Project Name: Addition

Building Address: 923 Clemensen Ave. Santa Ana

**RESIDENTIAL PLAN CHECK
 COMMENTS**

PLAN CHECK NO:	10173676	
PROJECT ADDRESS:	923 E Clemensen Ave	
PLAN CHECK ENGINEER:	George Moran	TEL: 714 667-2771
		FAX: 714 647-5897
TYPE OF CONSTRUCTION:	V B	
OCCUPANCY CLASSIFICATION(S):	R-3, U	
PLAN CHECK DATES:		REMARKS/RECHECK ITEMS:
APPLICATION	11/10/2011	
INITIAL REVIEW	12/6/2011	
EXPIRATION	5/8/2012	
RECHECKS:	1.	PROJECT APPLICANT CONTACT PERSON:
	2.	Steve Gnadt
	3.	TEL: (714)342-4814
		FAX:
VALUATION:	\$29,000.00	EMAIL: stevegnadt@birchwood-builders.com
FLOOD ZONE:	AE-0602320163J

SECTION "C"

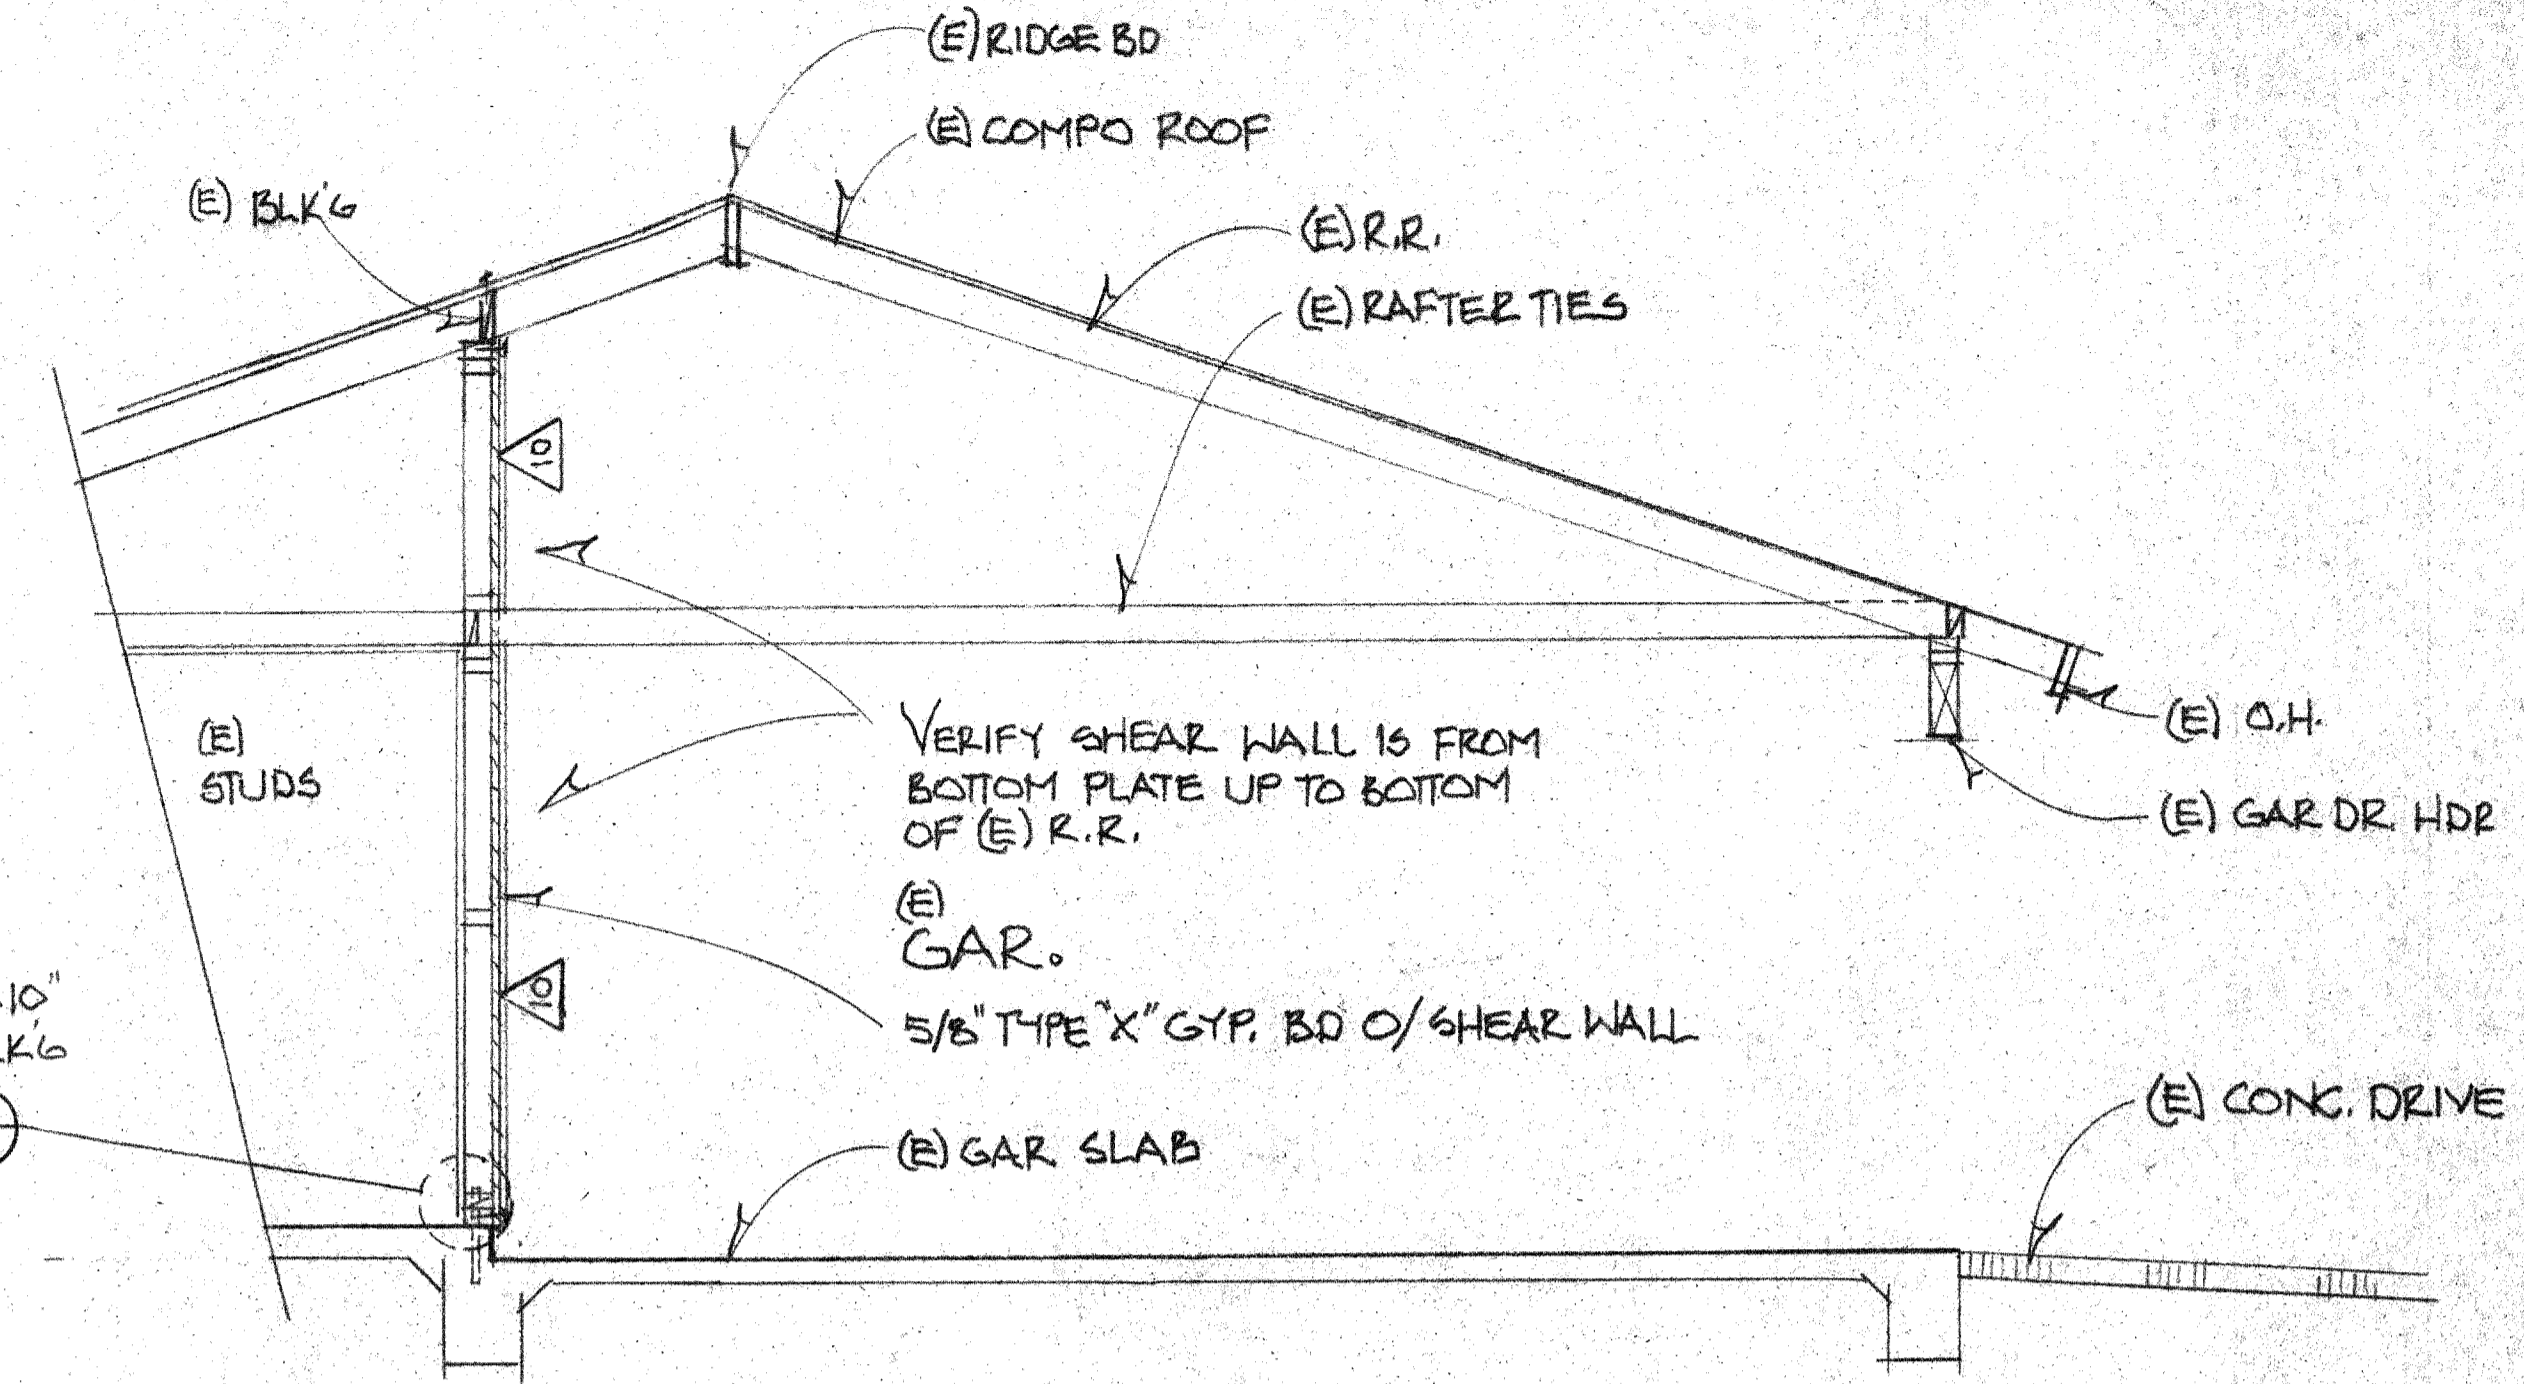
- 27. Detail how the interior shear walls are connected to the roof/floor diaphragm(s). (1603) *SEE NEW SECTION "C" SHEET 5*
- 28. The City has encountered a large number of inspection problems arising from a lack of specific framing details. The following listed items are required to be shown on the plans (CBC 107.1):

SECTION "B"

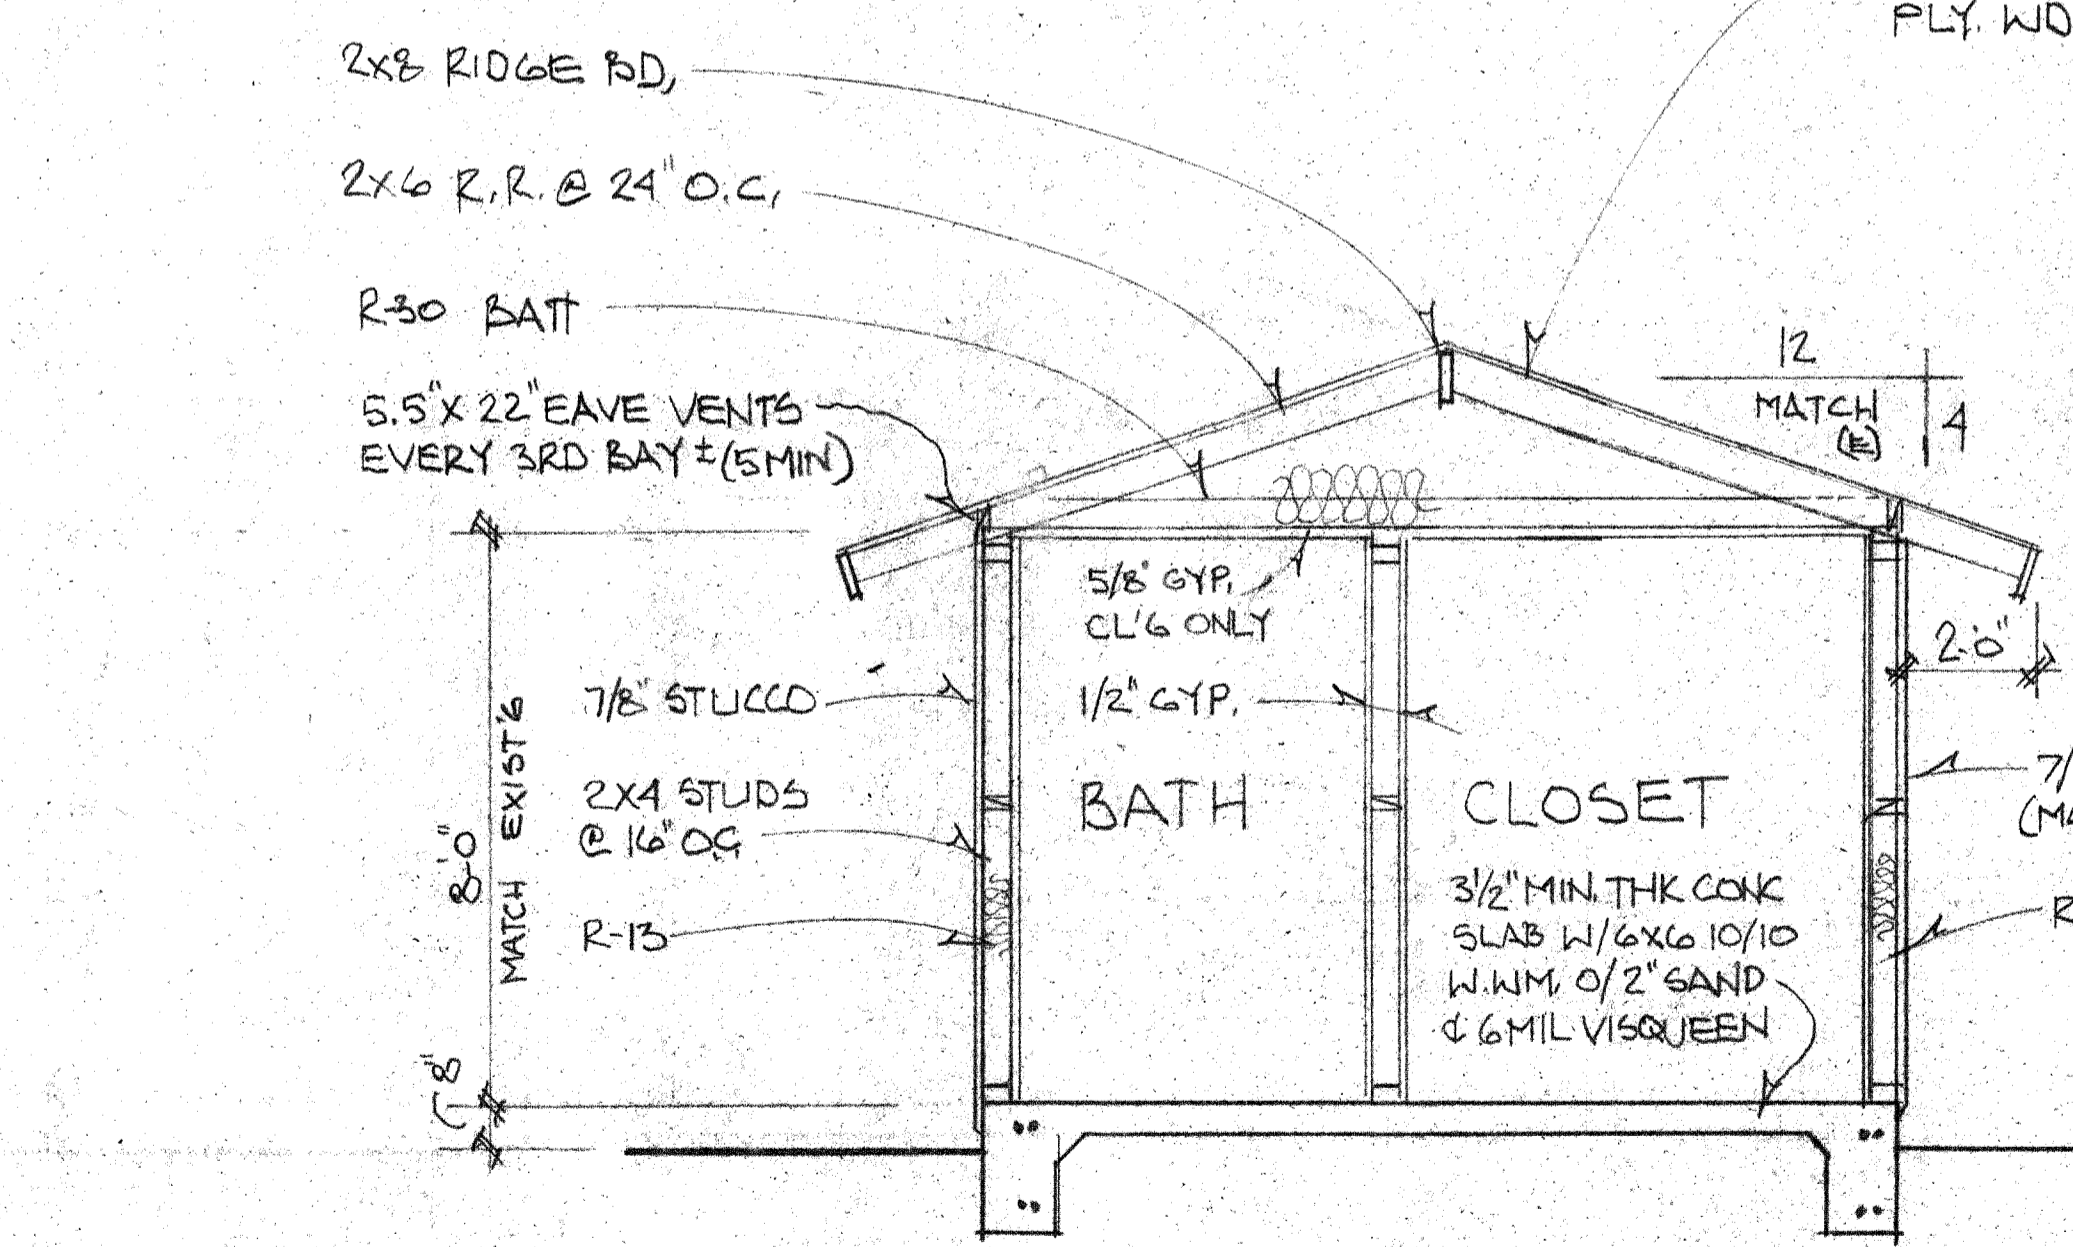
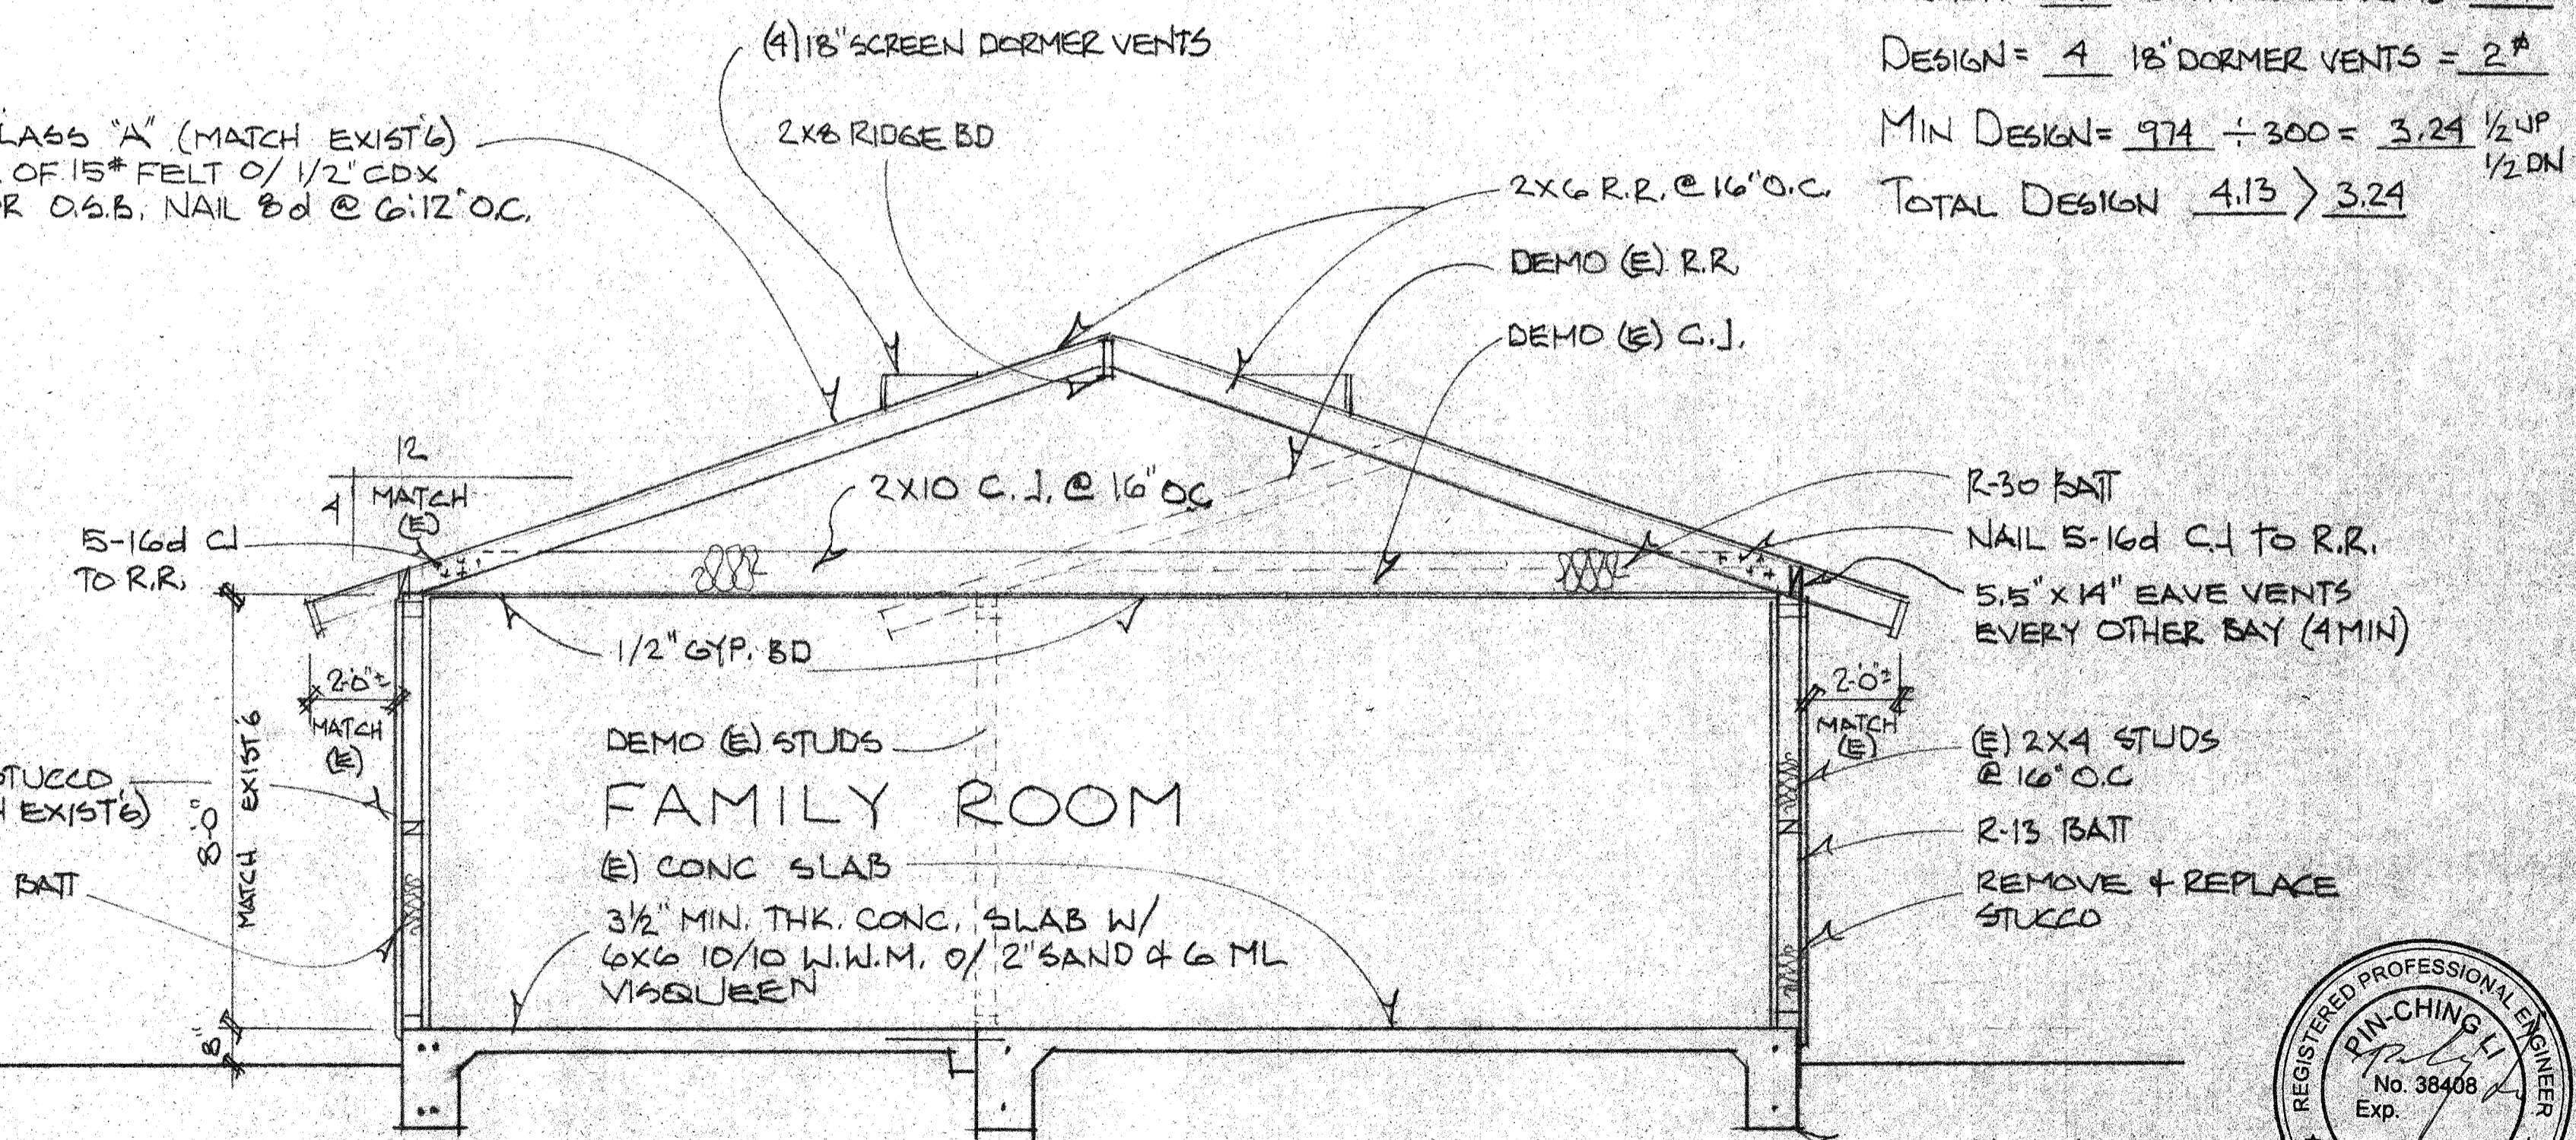
- 19. Provide cross ventilation for attic and each enclosed rafter space as specified in CRC Section R806. *OK EAVE + DORMER VENTS SEE SHEET 5 & 6*
- 20. Callout attic vent locations, sizes and types on plans. Provide attic ventilation calculation to show minimum ventilation is provided. (CRC R806.2) *CALCS ON ATTIC SEE SHEETS*

ATTIC DATA:
TOTAL ATTIC OVER FAMILY RM 974"
DESIGN = 4 5.5" x 14" EAVE VENTS = 2.13"
DESIGN = 4 18" DORMER VENTS = 2"
MIN DESIGN = 974 ÷ 300 = 3.24 1/2 UP 1/2 DN
TOTAL DESIGN 4.13 > 3.24

LEFT ELEVATION

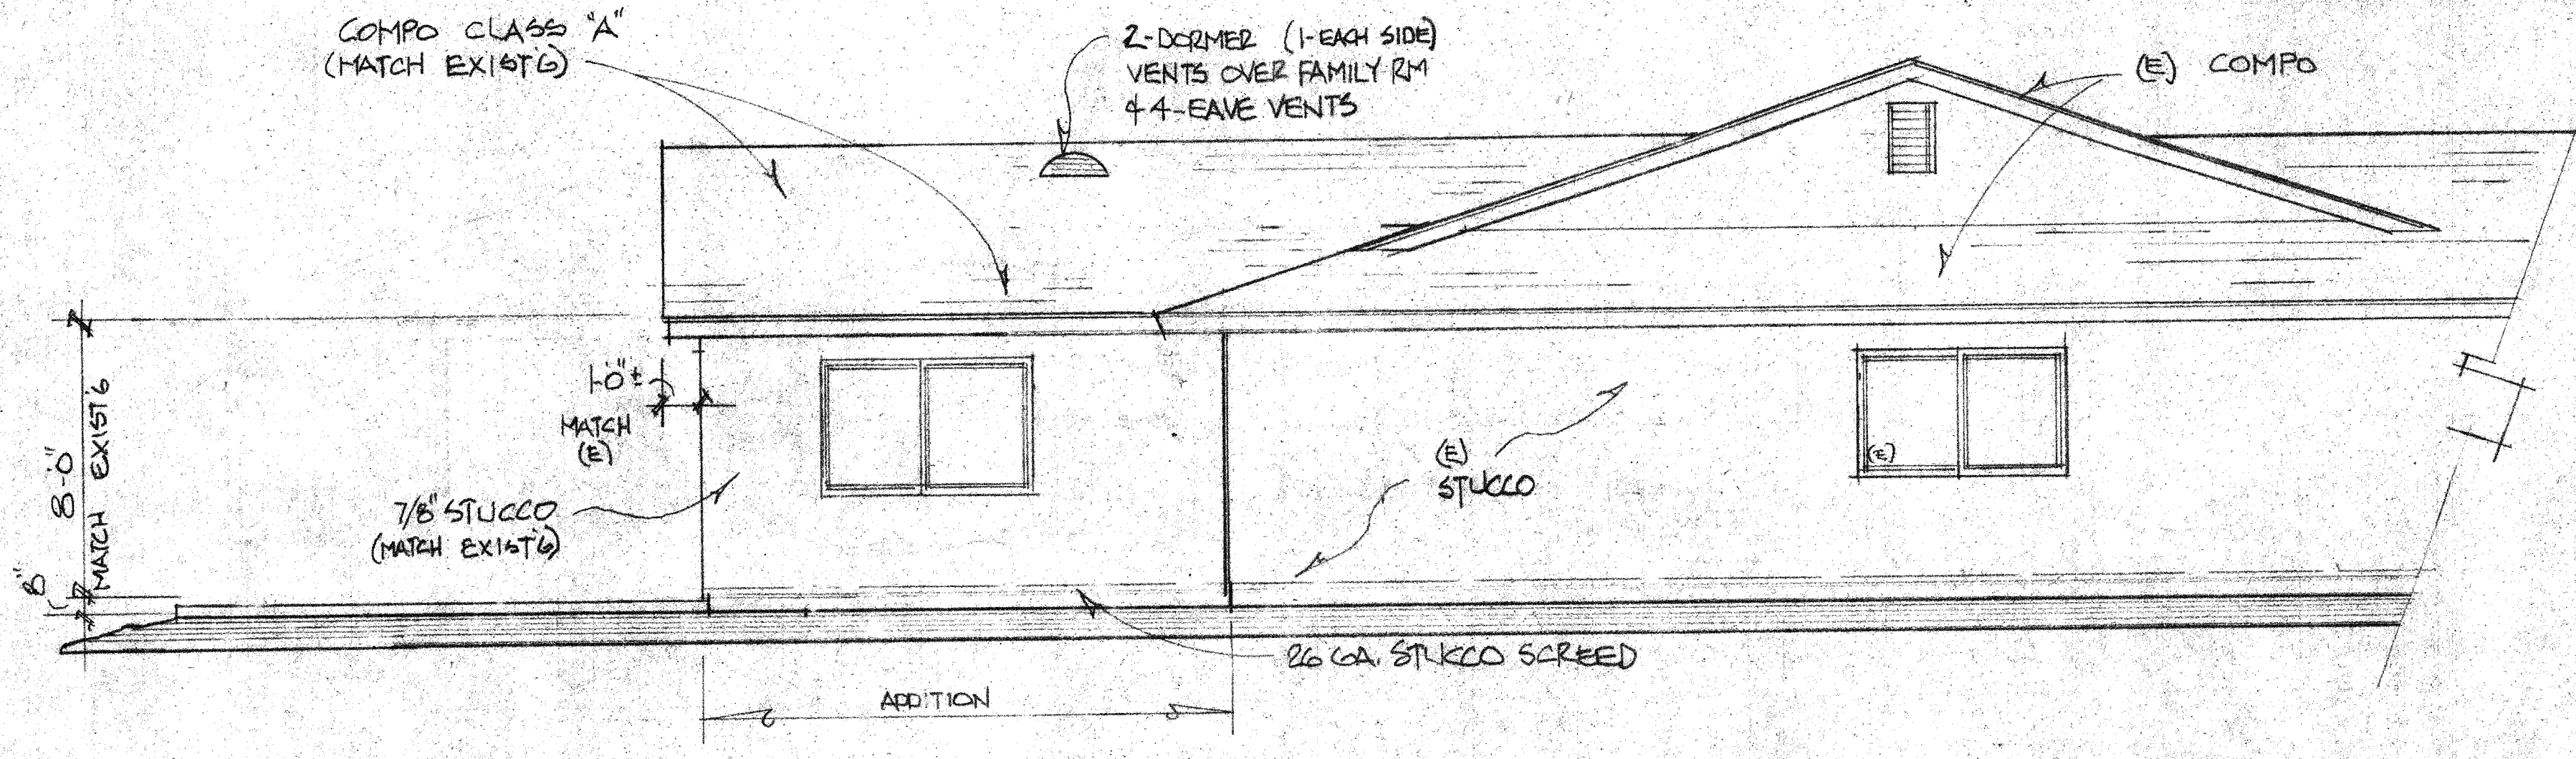
(34) on left elevation show Bedrooms windows and Maximum 44" sill height.

YES I HAVE CHANGED
BUT WINDOW IS A 3' WIDE X 4' TALL
 $6'-8" - 4' = 2'-8" = 32"$ AND IS NOT
MAIN FIRE ESCAPE WIN THE OTHER
5' X 4' WIN IN BEDROOM IS
SEE ELEV ON SHEET 6
